Interstoff Cloathing Ltd. #9494

06.May.2014

ACC RD
on Fire and Building Safety in Bangladesh

No guard rail was found at the roof of the utility building close to exit.

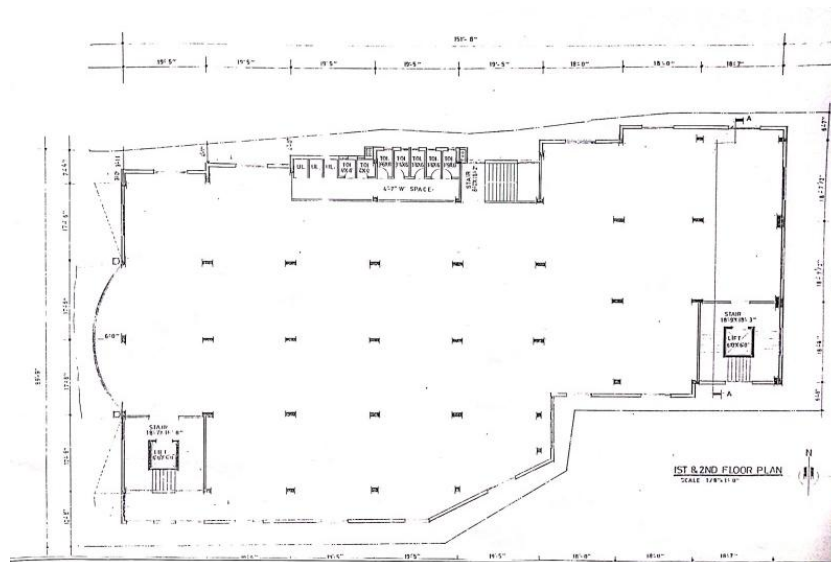
1st Priority 3 - Concern

The utility building has no hand rail or security element in place close to the access door at the roof. A security element could prevent the fall of a worker.

Distance between ledge and door is roughly 1220 mm
